REMARKS/ARGUMENTS

Appl. No. 09/938,040
Amdt. dated Oct. 17, 2003
Reply to Office action of Aug. 6, 2003

FIG. 1 - Prior Art

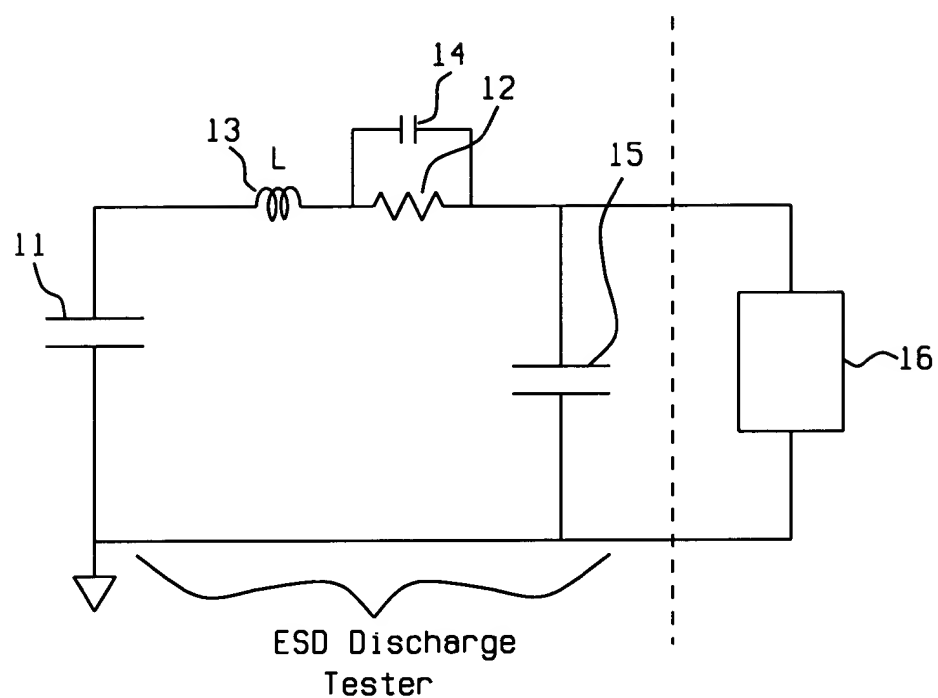
In amended Figures 1 and 2, the previously omitted legend --Prior Art-- has been added.
